**CITY OF FRANKLIN****REPORT TO THE PLAN COMMISSION****Meeting of November 21, 2019****Special Use and Site Plan Amendment**

Project Name:	The Learning Experience Special Use and Site Plan Amendment
Project Address:	7760 Lovers Lane Road
Applicant:	Gary Wendt, Bradford Franklin LLC
Property Owner:	Franklin-Wyndham, LLC
Current Zoning:	CC City Civic Center District
2025 Comprehensive Plan	Mixed Use
Use of Surrounding Properties:	Single-family residential to the north, stormwater detention pond to the south, Risen Savior Lutheran Church to the east and Summit Credit Union to the west
Applicant Action Requested:	Recommendation of approval for the proposed Special Use and associated Site Plan for the development of The Learning Center daycare facility.

THE LEARNING EXPERIENCE
7760 S LOVERS LANE RD
FRANKLIN, WI
WYNDHAM VILLAGE LSR EXHIBIT

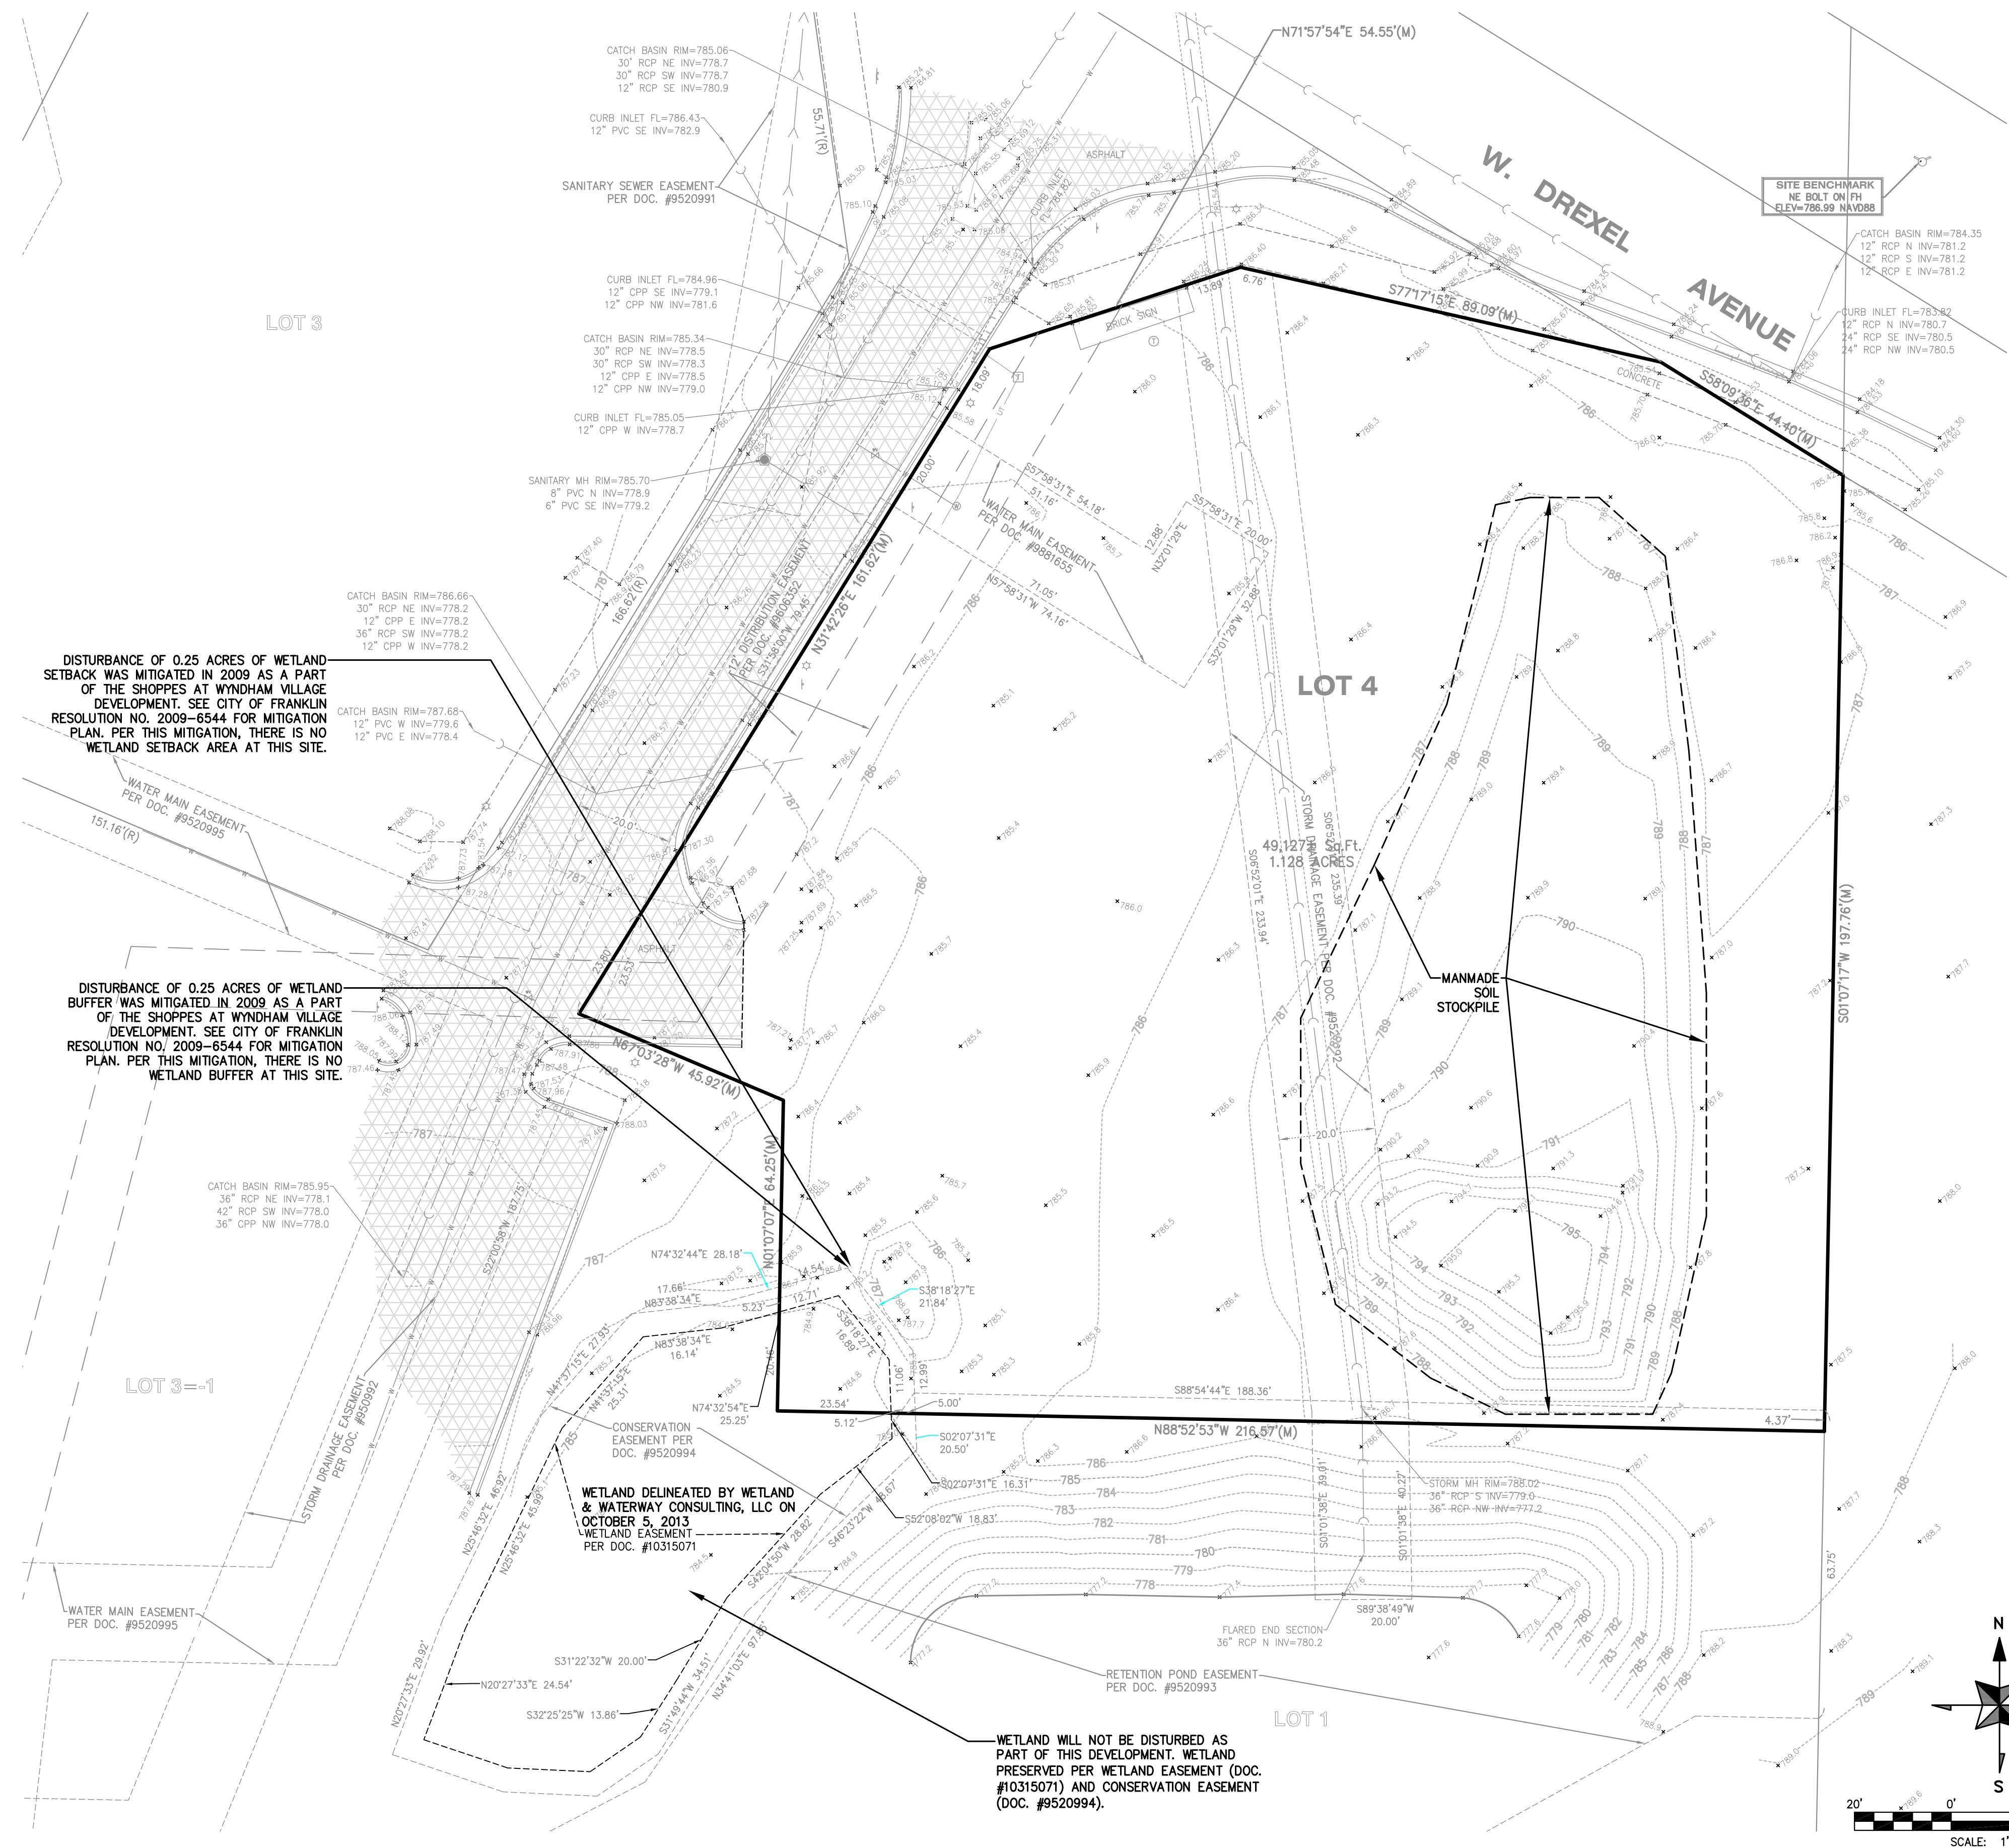
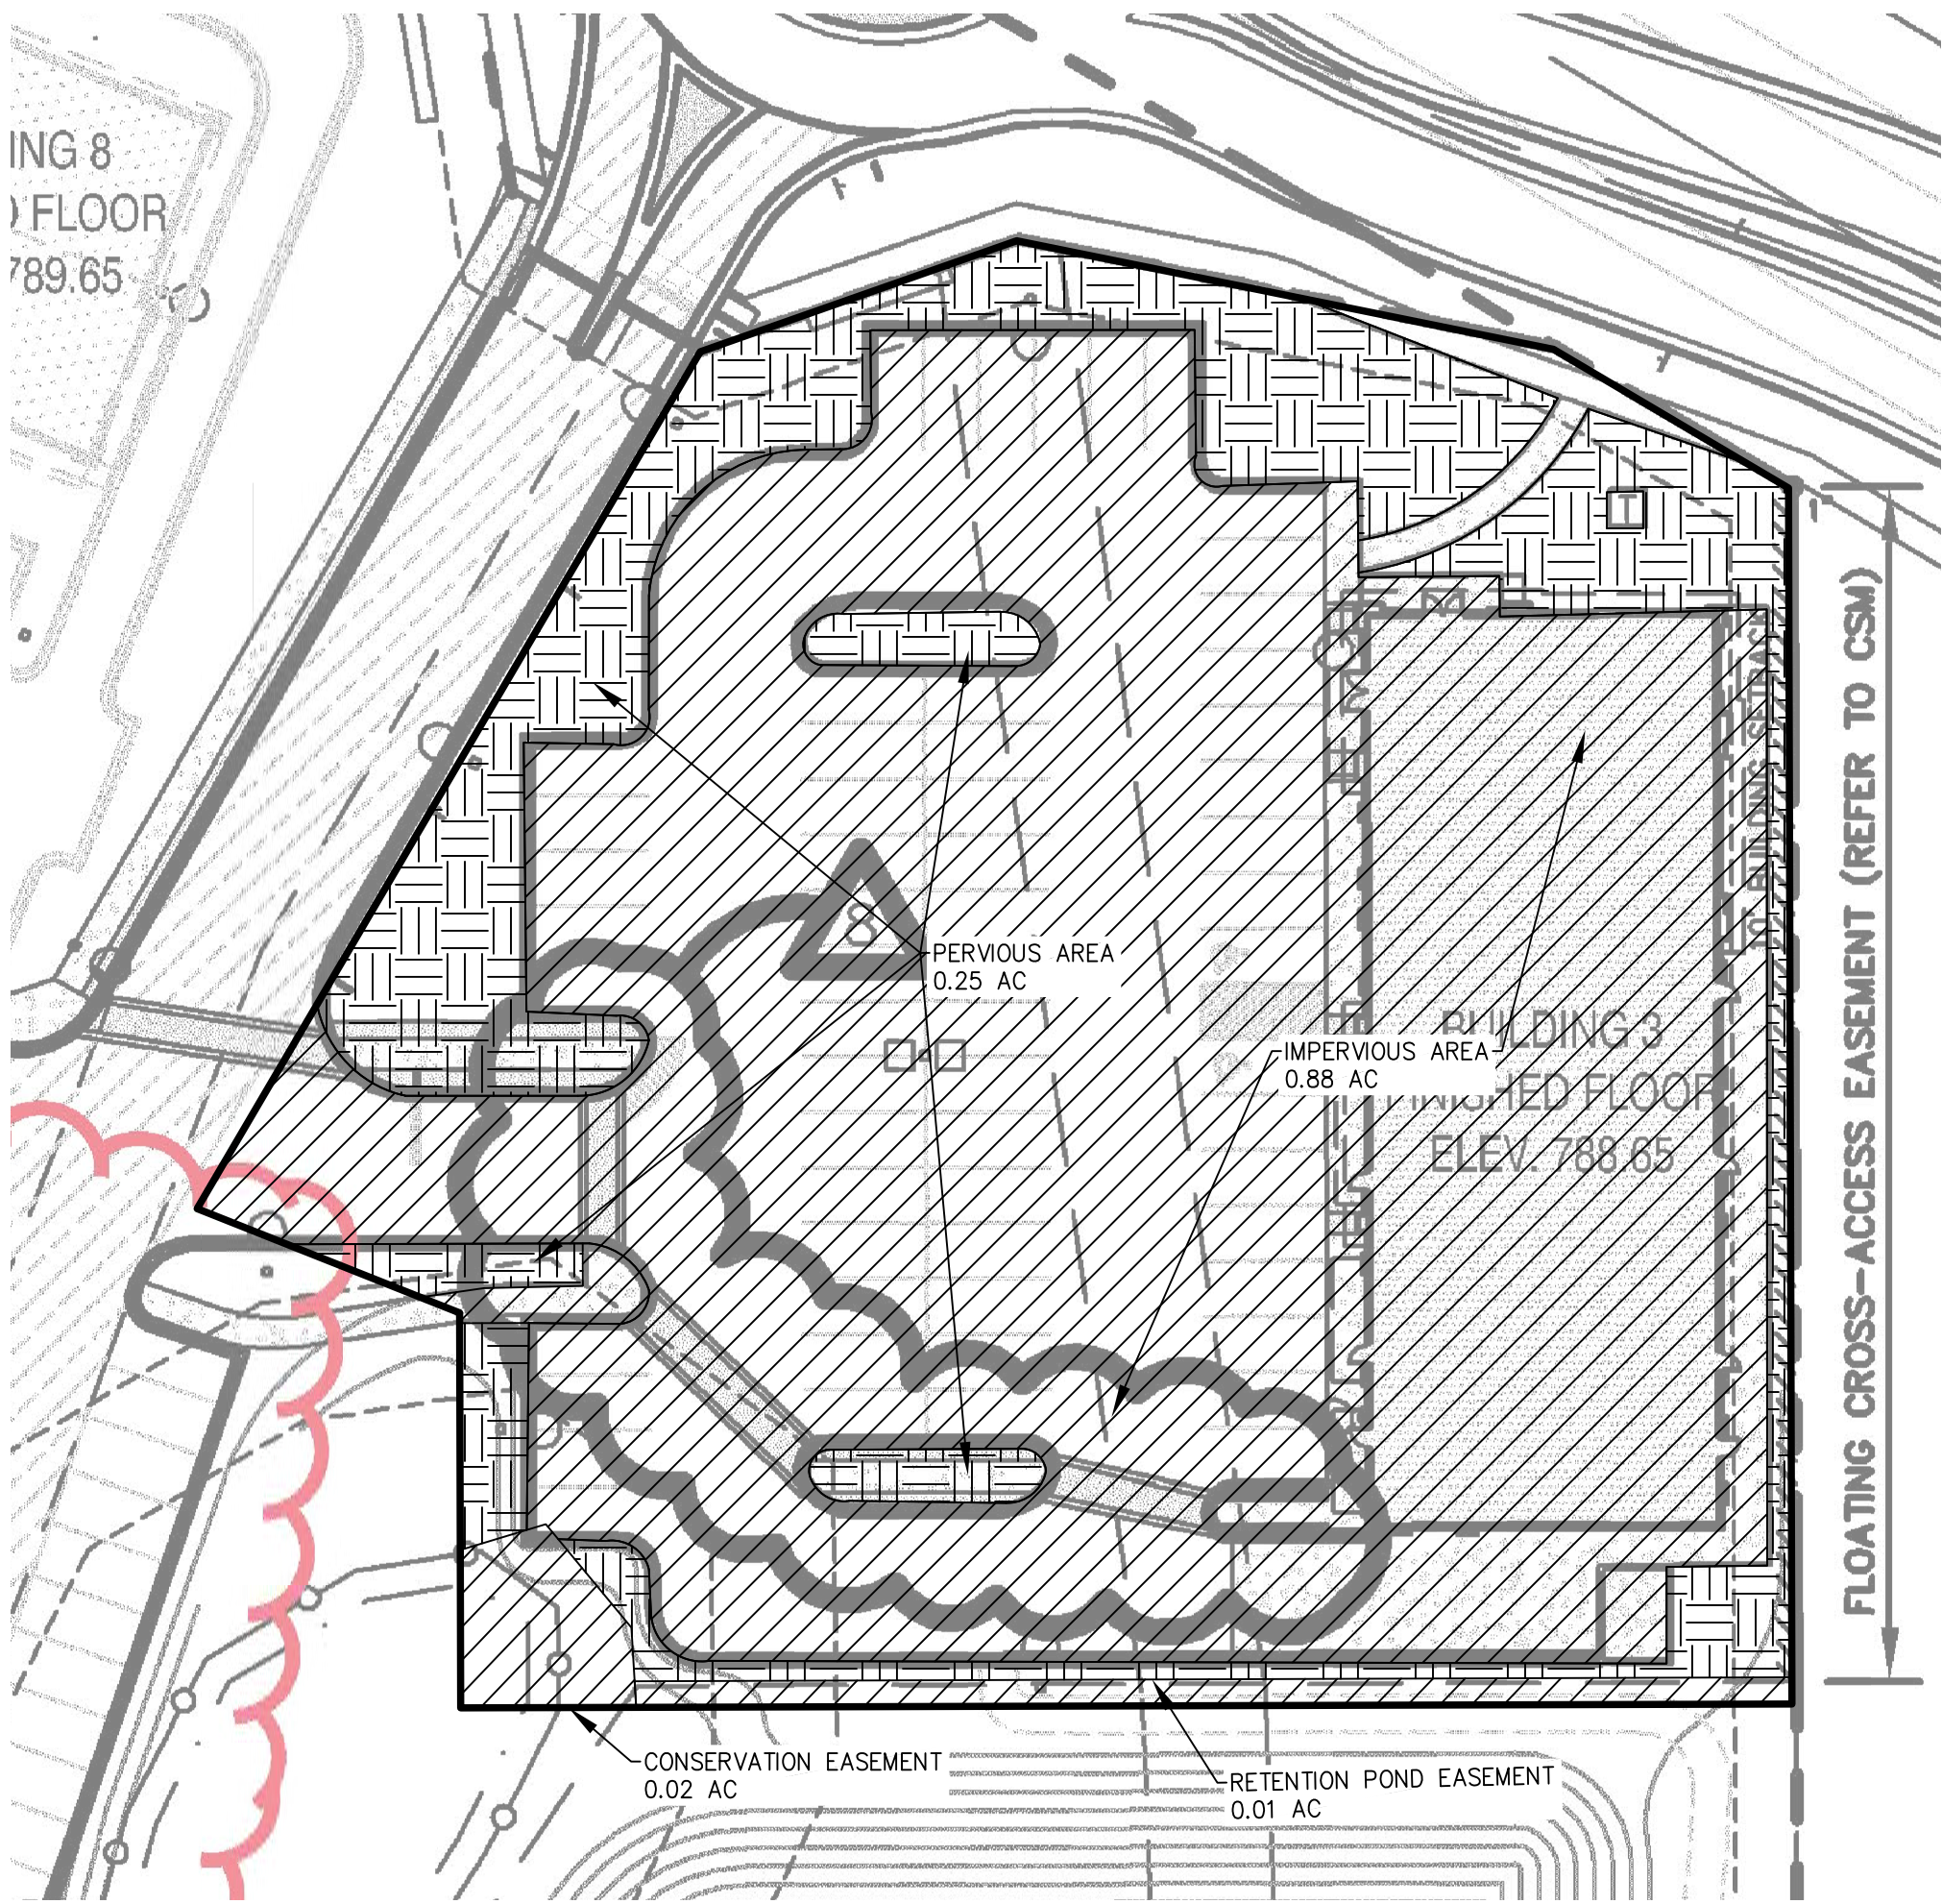
Comment 3: Please include additional site data, such as square footage of proposed impervious surface, greenspace and Landscape Surface Ratio (see definitions below).
Landscape Surface Ratio (LSR). The ratio derived by dividing the area of landscaped surface by the base site area.

Response 2a: These calculations are shown on the Wyndham Village LSR exhibit and the NRPP. The area of the approved Wyndham Village impervious area for Lot 4 (the area of The Learning Experience project) was examined. A comparison of the approved LSR for this area and the Proposed TLE project has been provided. (In the meeting with staff it was discussed that an aerial photograph analysis be performed. However, there are several vacant lots within the subdivision which precluded this method of analysis.)

Response 3: These areas are Shown on the Site Plan, the NRPP and the Wyndham Village LSR Exhibit.
